CITY OF SIMI VALLEY

January 19, 2006

SUBJECT: COMMENTS ON DRAFT 2006 303(d) LIST

Figure 1. Calleguas Creek Watershed

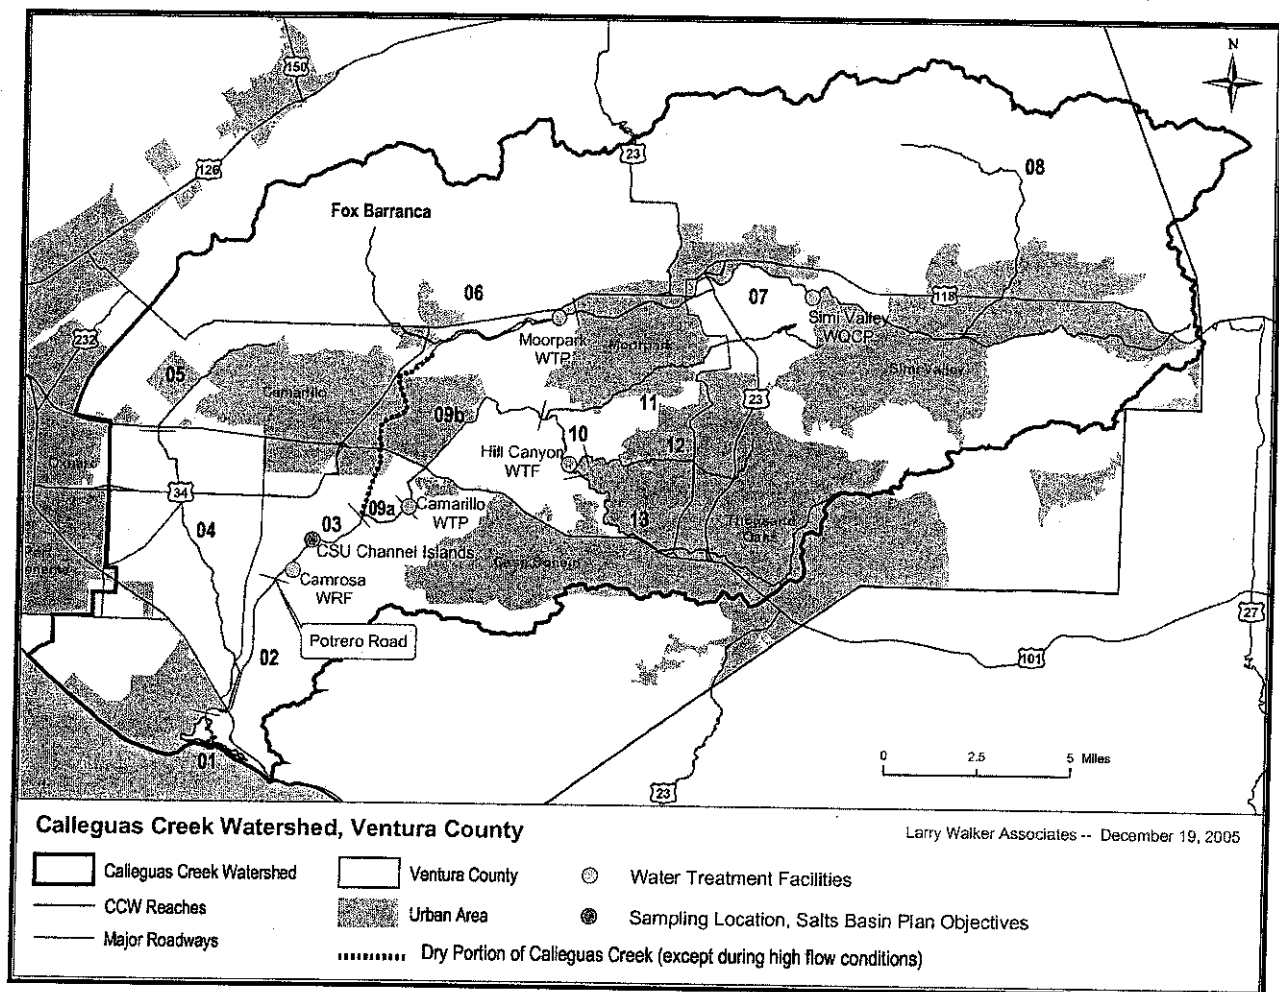
The numeric objectives for chloride and sulfate were changed and the reach designations changed from "at Potrero Road" to "above Potrero Road". Table 1 summarizes the 1975 and 1978 Basin Plan objectives along with the data on which the 1978 objectives are based. The 1978 water quality objectives were based on existing data from 1975-1977. These data were collected at what was then the Camarillo State Hospital and is now the California State University Channel Island (CSUCI) campus (Figure 1 and Attachment 1).

The discussion about the changes made in 1978 indicate that the objectives in the Basin Plan were only intended to apply to the lower Calleguas and Conejo Creek reaches of the watershed (Reaches 3, 9A, 9B, and 10), not Reaches 6, 7, 8 and Fox Barranca, which make up the Arroyo Simi and Arroyo Las Posas systems. The stated reasons for changing the objectives were that the objectives are inconsistent based on the continuity of the waters. Furthermore, only the Hill Canyon and Camarillo WFPs are referenced as discharging to

the reach to which the objectives apply. The Moorpark and Simi Valley WWTPs were discharging to Reaches 6 and 7, respectively, in 1978 and are not described as discharging to the reach to which the objectives apply. Additionally, the monitoring station on which the objectives are based is located in the lower Calleguas (Reach 3) at the CSUCI gauging station. Surface flow from Reaches 6, 7, 8 and Fox Barranca does not reach this station except during wet weather events meaning that these surface waters are not contiguous except during high flow events (Figure 1). The change from “at Potrero Road” to “above Potrero Road” resulted in the application of water quality objectives to Reaches 6, 7, 8 and Fox Barranca that were intended to apply only to Reaches 3, 9A, 9B, and 10.

The administrative record clearly shows that 1) the boron, chloride, sulfate, and TDS objectives were set based on existing water quality concentrations (e.g., Anti-degradation Policy), not on the protection of specific beneficial uses; and, 2) the objectives were intended to be applied to reach 3 of the watershed. Therefore, no objective for boron, chloride, sulfate, or TDS exist for Reaches 6, 7, and 8 of the watershed. As such, these impairments should be de-listed, as there are no water body-specific objectives available for these constituents.
